April 6, 2012

Cogentrix Quail Brush Generation Project – Docket Number 11-AFC-3, Data Request Responses to Set 2

Transmission System Engineering

ATTACHMENT A
QUAIL BRUSH KEY ONE-LINE DIAGRAM

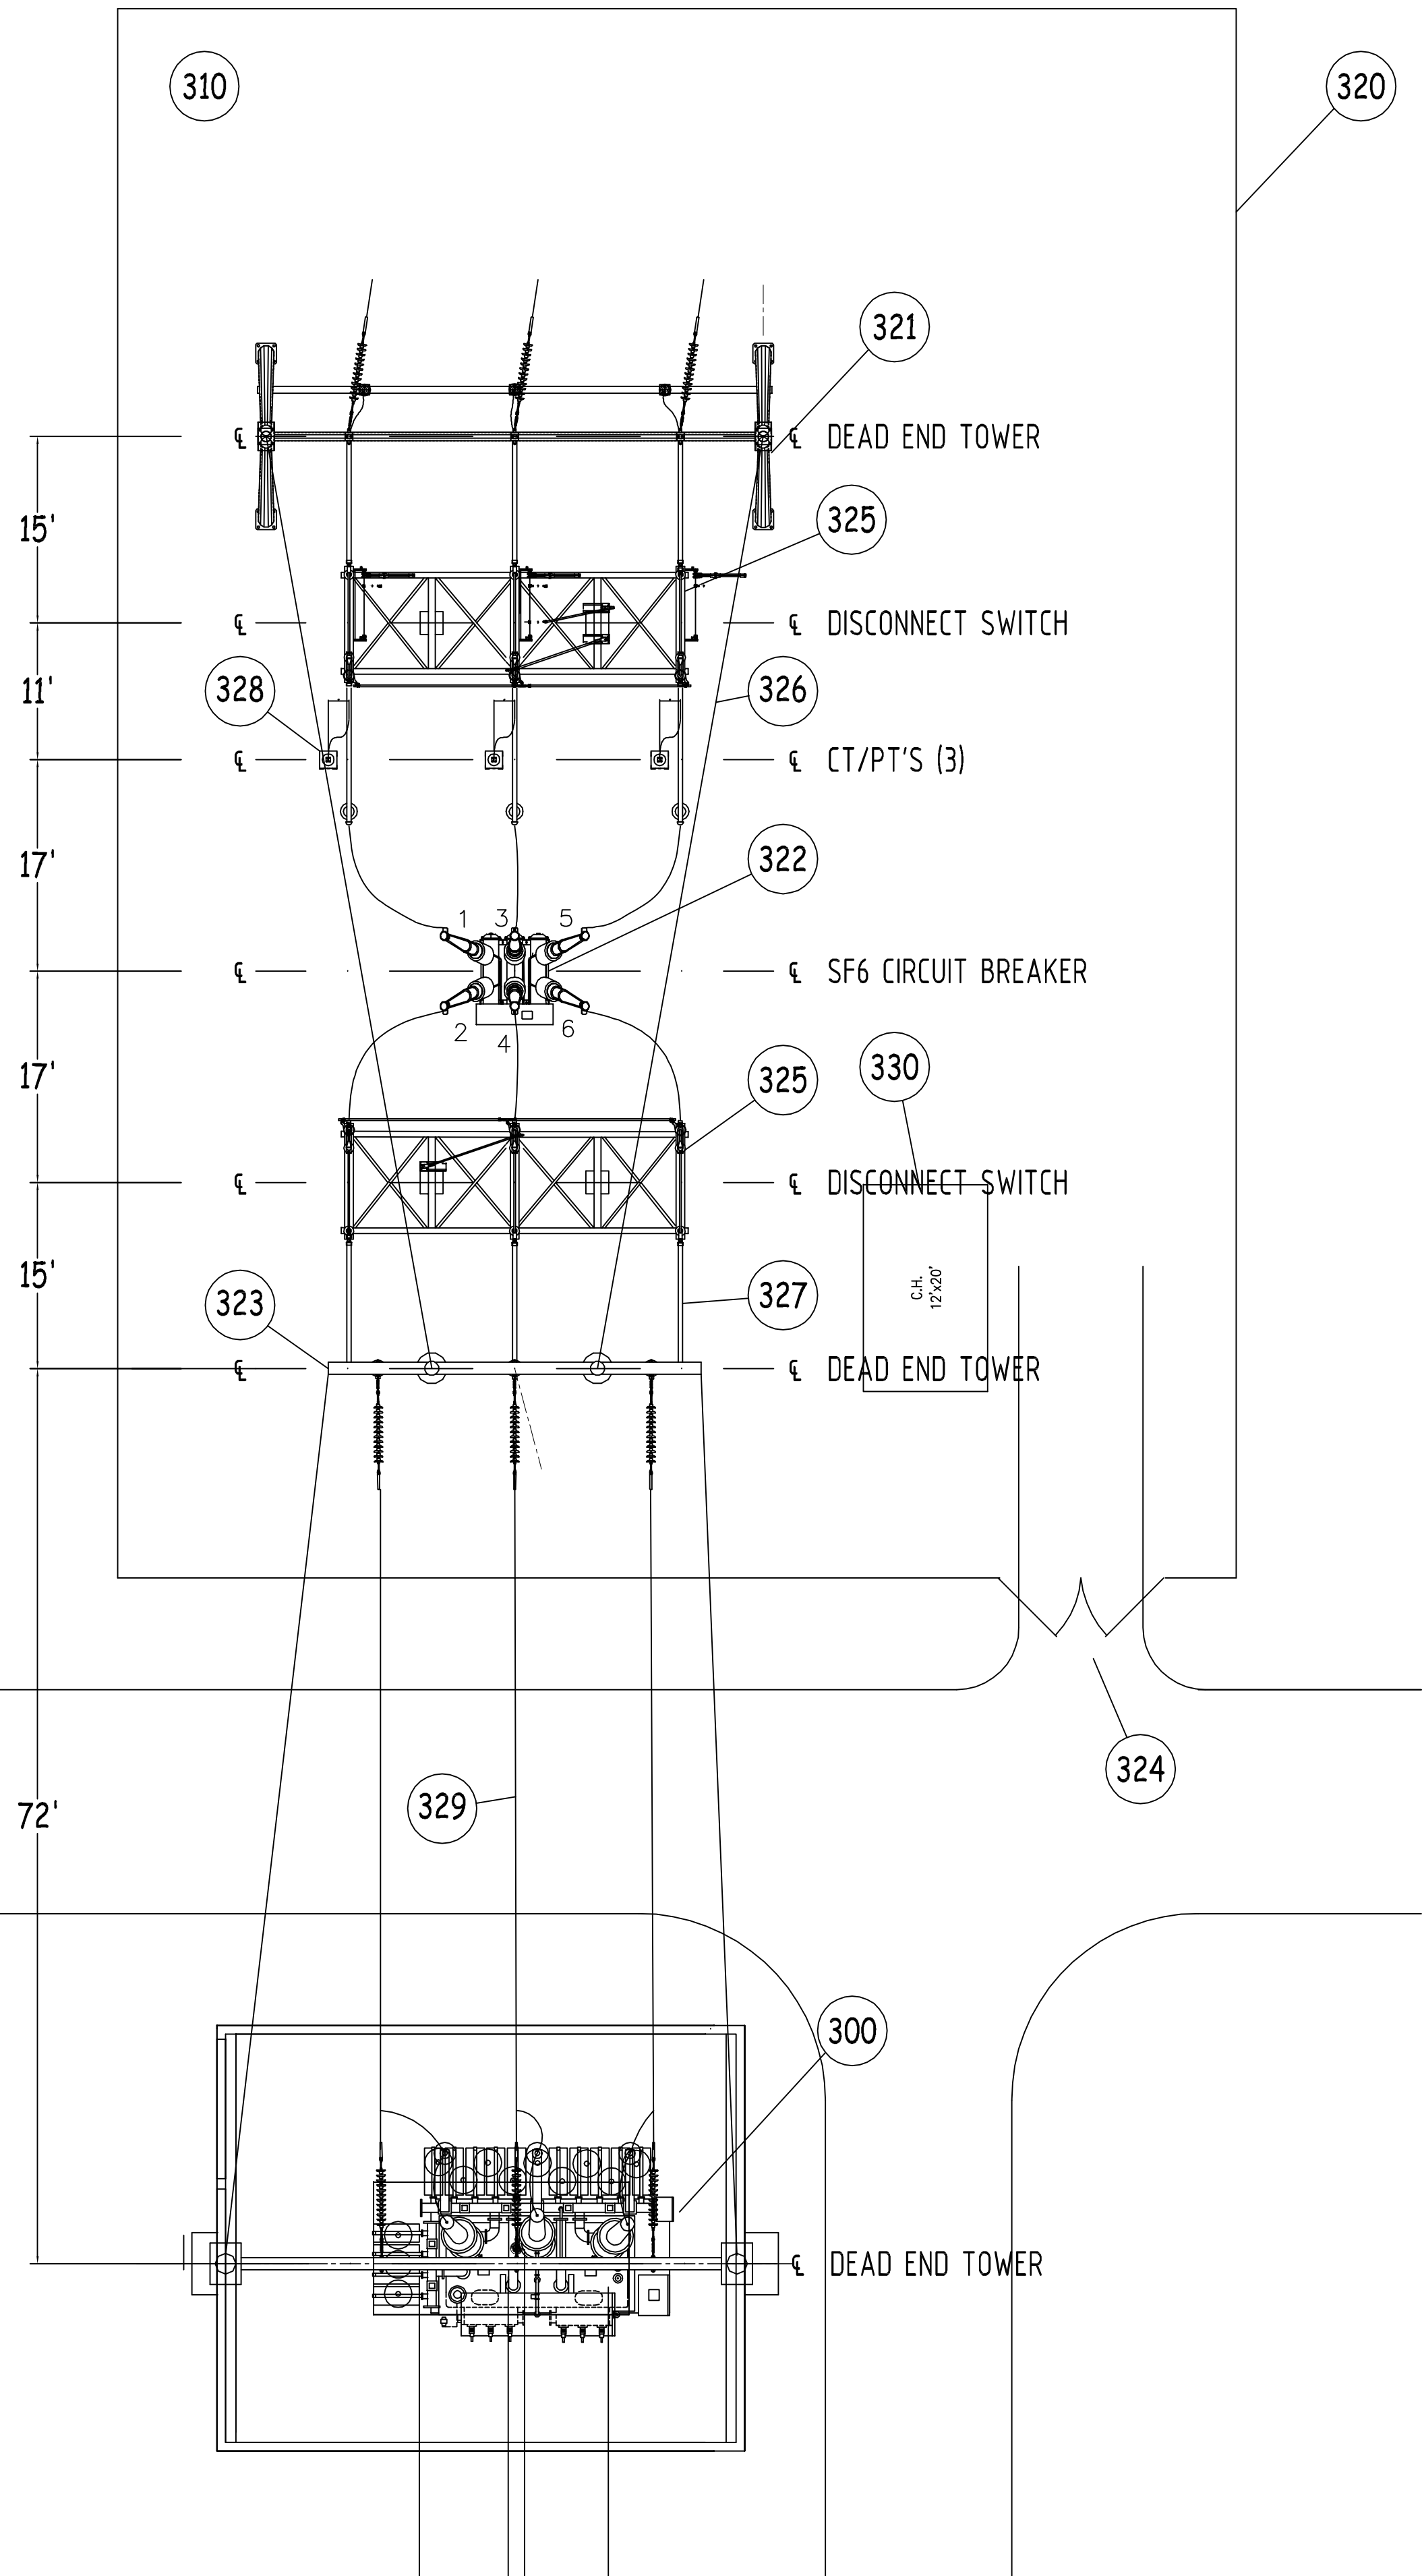
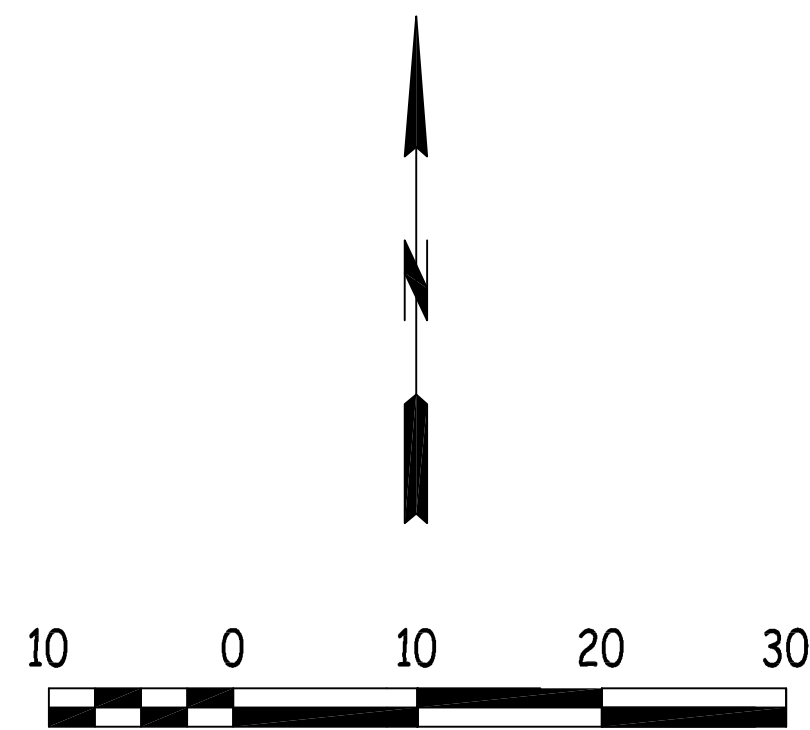
59. Provide a complete electrical one-line diagram (or resubmit Exhibit 4 with amended size/ratings of the applicable equipment and/or missing elements) of the proposed QGBP 138/13.8 kV switchyard showing all equipment for all eleven generator units' interconnection with the switchyard with their respective sizes and/or ratings as follows: i) Any bus duct connectors or overhead conductors or cables, 13.8/15 kV switch gear, buses, breakers & disconnect switches on the low side of generator step-up transformer (GSU). ii) The GSU and short overhead conductors/cables from the GSU high side to the switchyard 138 kV bus with the configuration of the switchyard 138 kV buses, breakers, disconnect switches, along with the proposed generator (gen) tie line transmission outlet.

Drawing QBPP-E001 Rev. E "Quail Brush Key One-Line Diagram" is attached as Attachment A.

ATTACHMENT B
QUAIL BRUSH SWITCHYARD LAYOUT

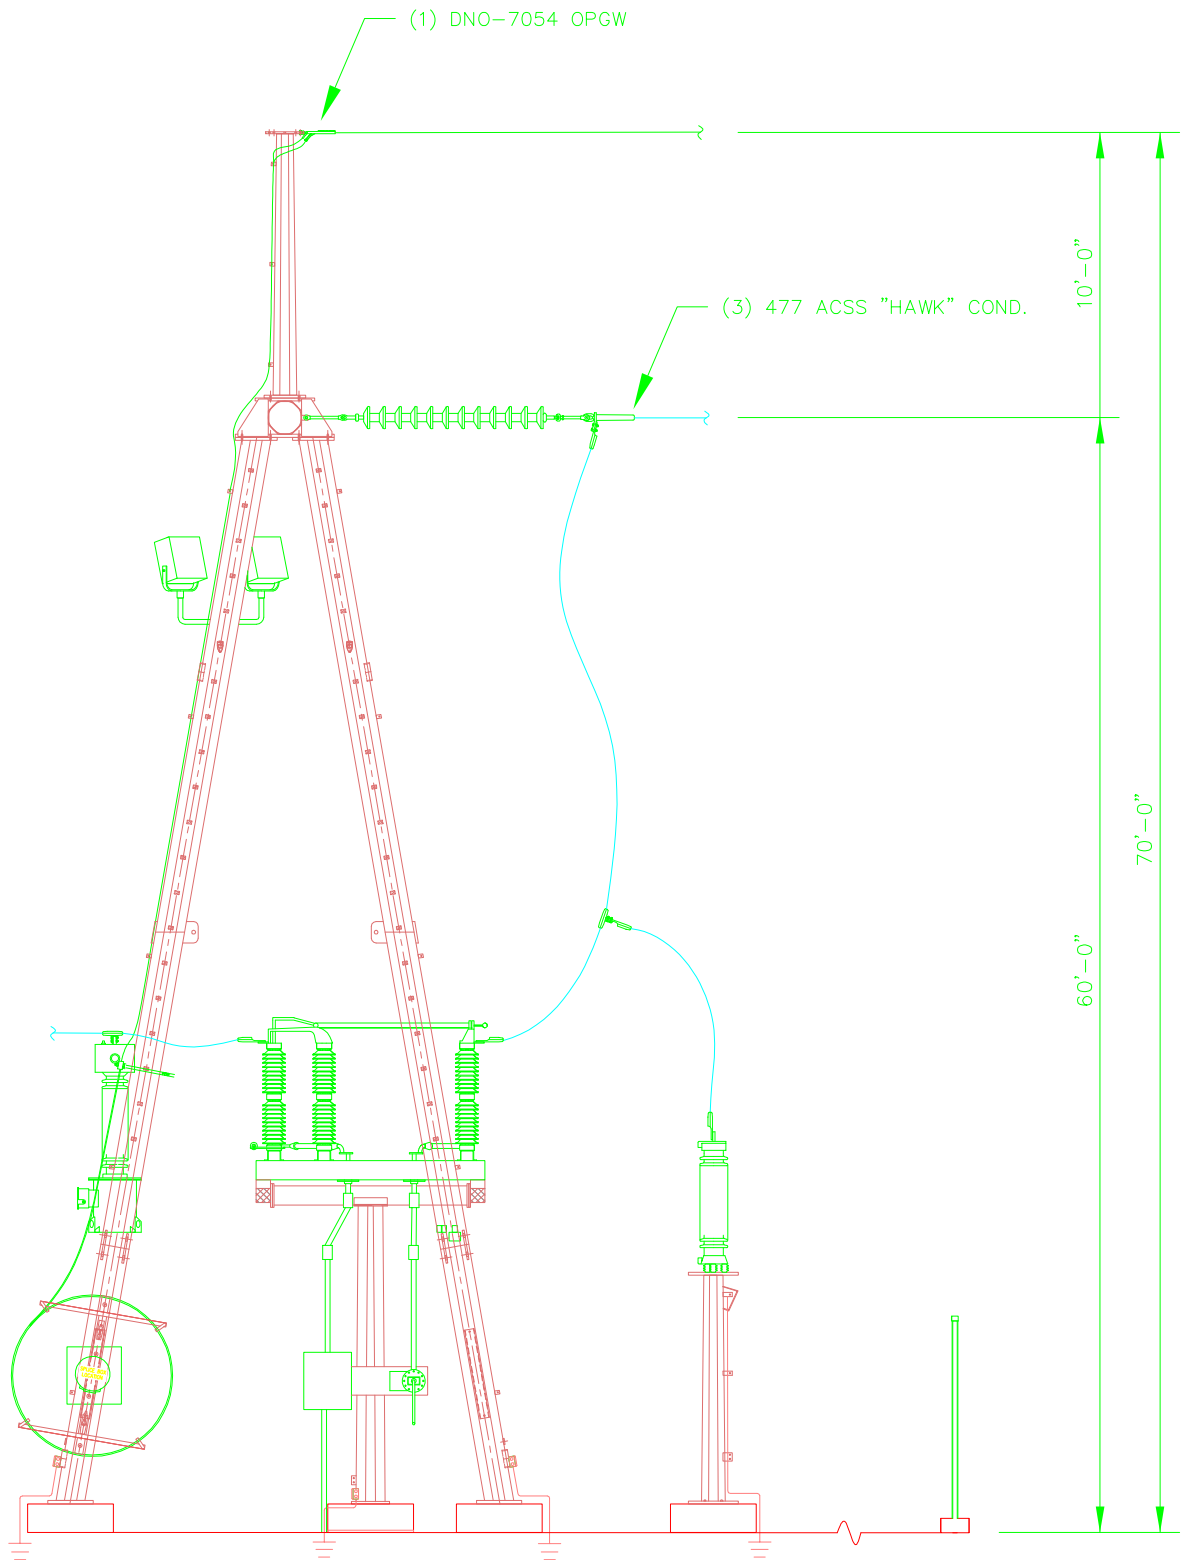
60. Provide a physical layout drawing of the QGBP 138/13.8 kV switchyard showing all major equipment (generators, buses, transformers, breakers and disconnect switches etc.) and transmission line outlet(s).

Drawing QB-SP-3 Rev. A "Quail Brush Switchyard Layout" is attached as Attachment B (based on the Site Plan included as Figure 2.3-1 from the AFC). A typical A frame structure is attached as Attachment C.

ATTACHMENT C
TYPICAL A FRAME STRUCTURE

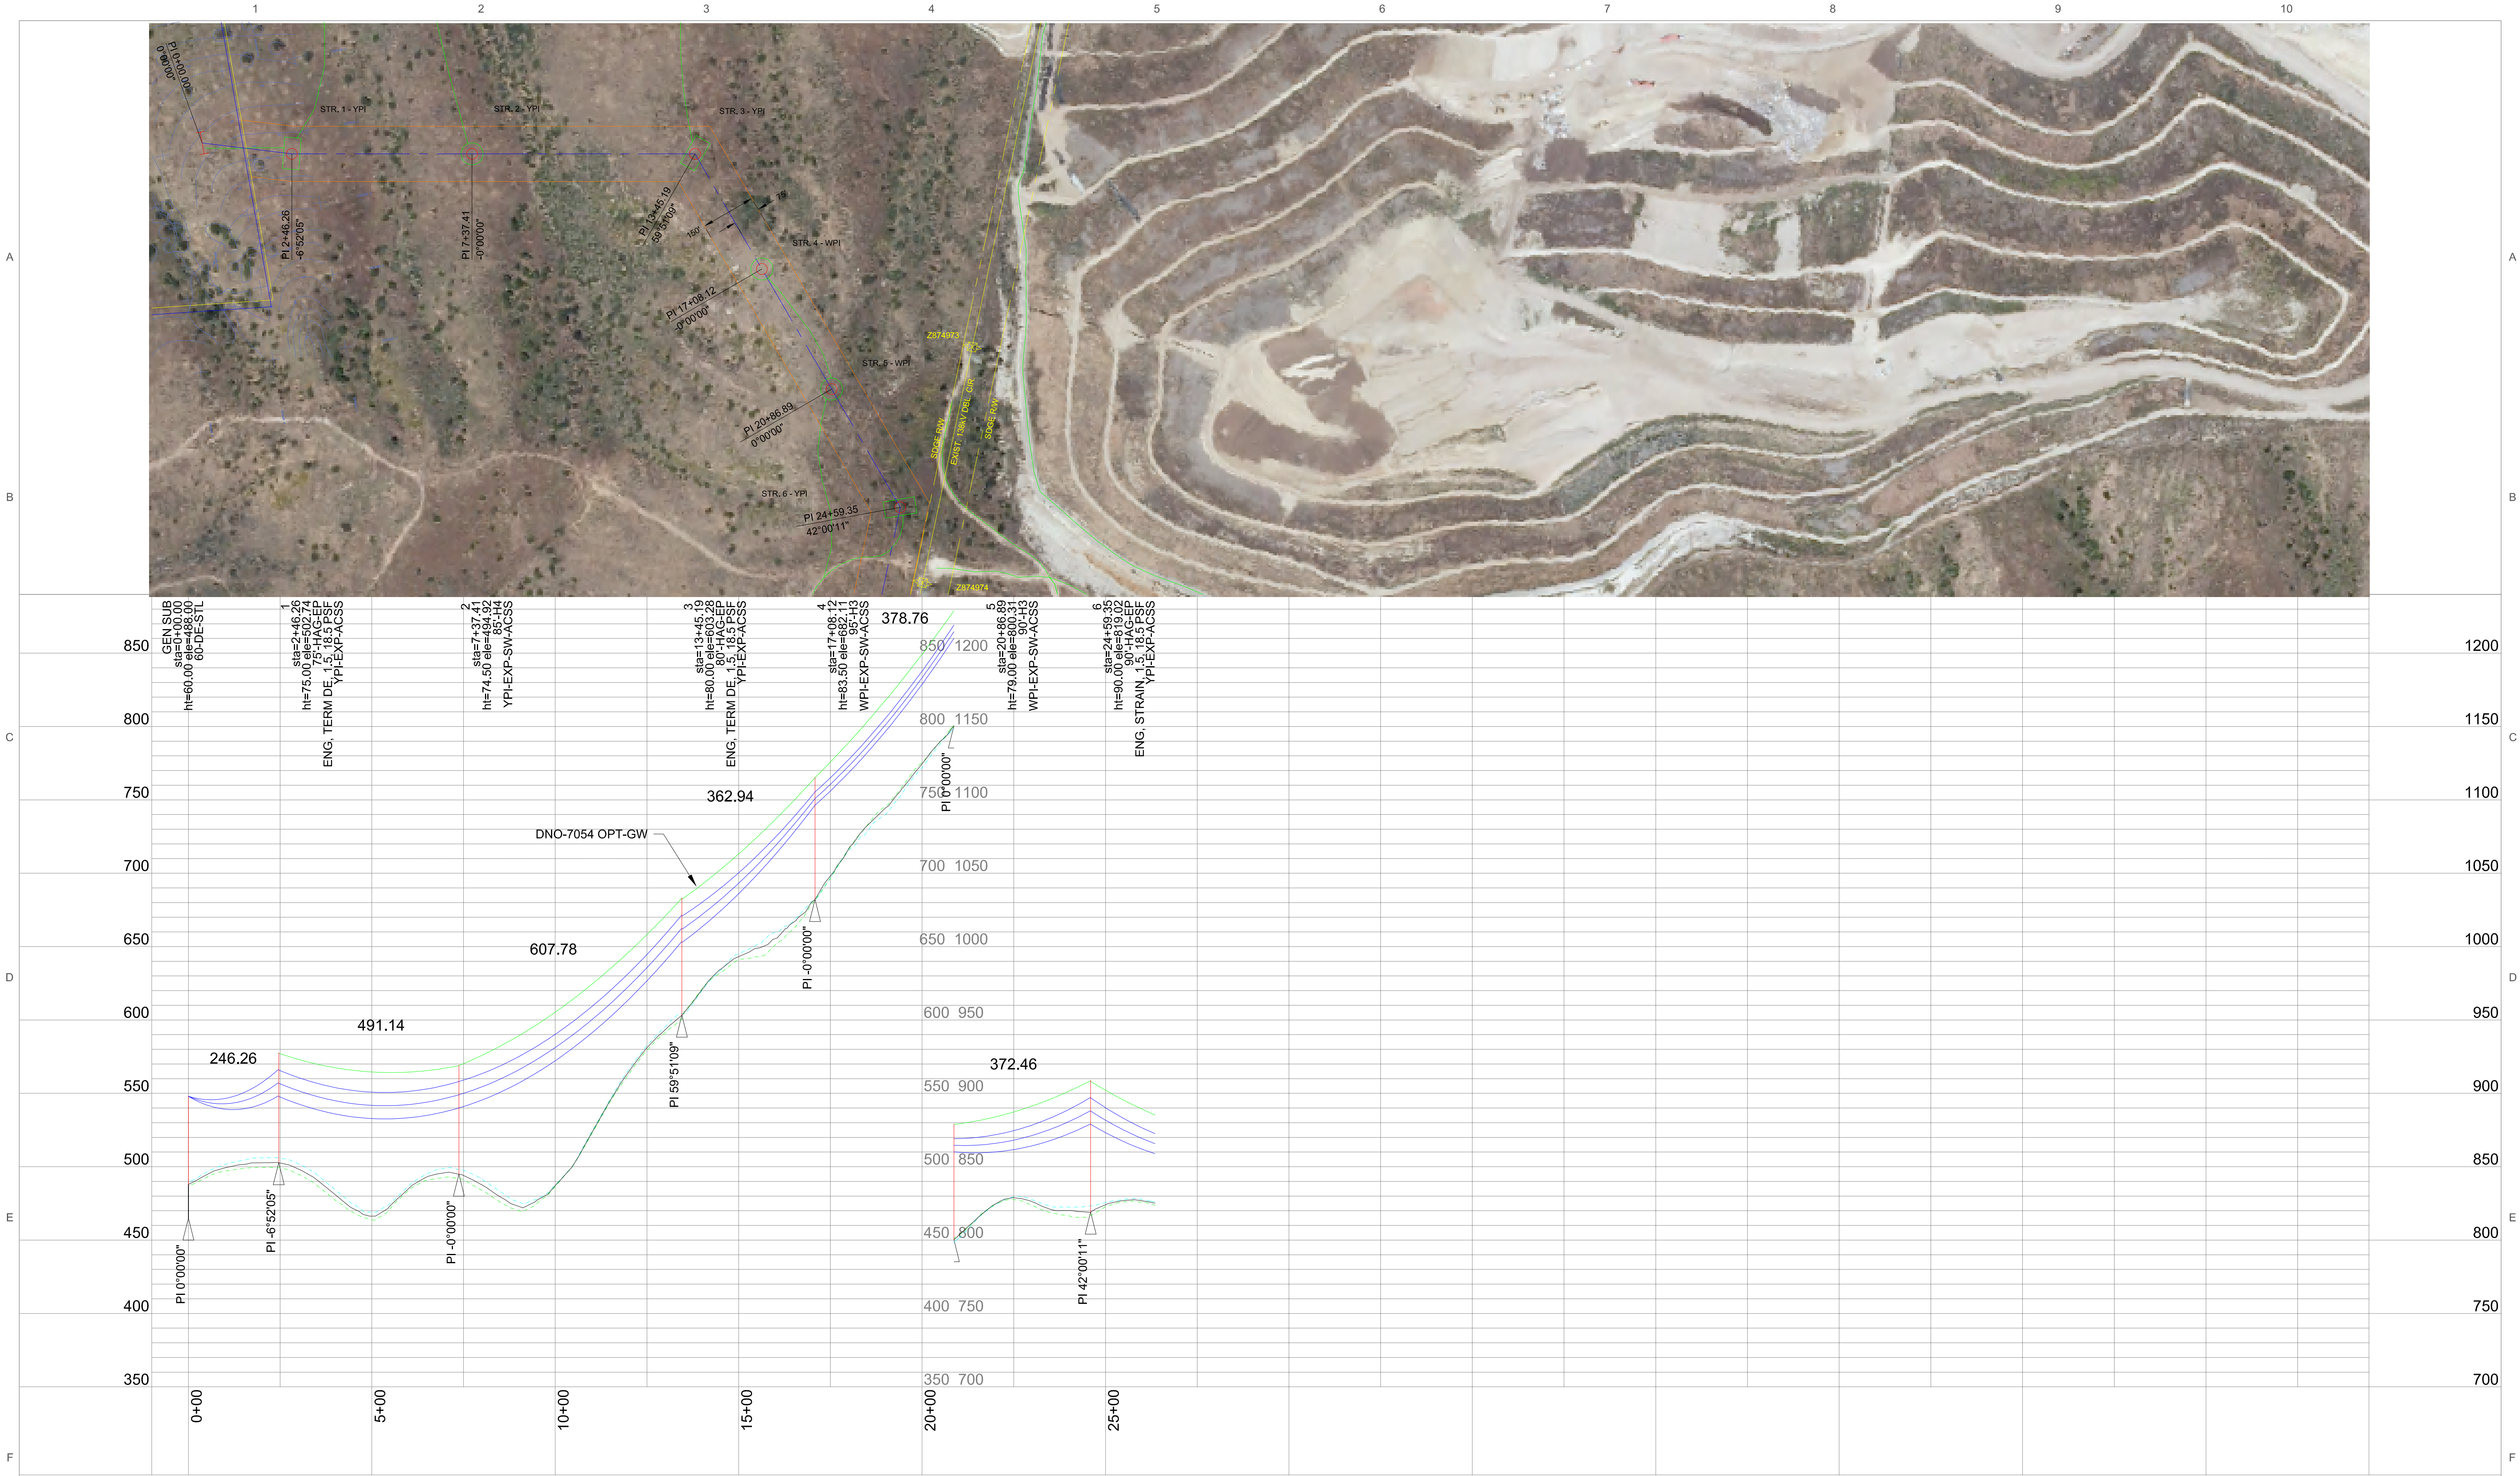
62. Please submit design diagrams of the tangent steel pole and heavy-angle steel pole showing configuration of insulators and conductors with their respective position measurements on the pole including ground clearance from the lowest conductor, height of the pole above and below ground, and the ground conductor, if any, with its size. Also include similar design diagrams of the dead-end poles or structures for the overhead gen tie line at each end.

The dead-end pole at the QBGP switchyard is depicted on Attachment C. The dead-end pole at SDG&E's Carlton Hills substation is depicted on Attachment L.
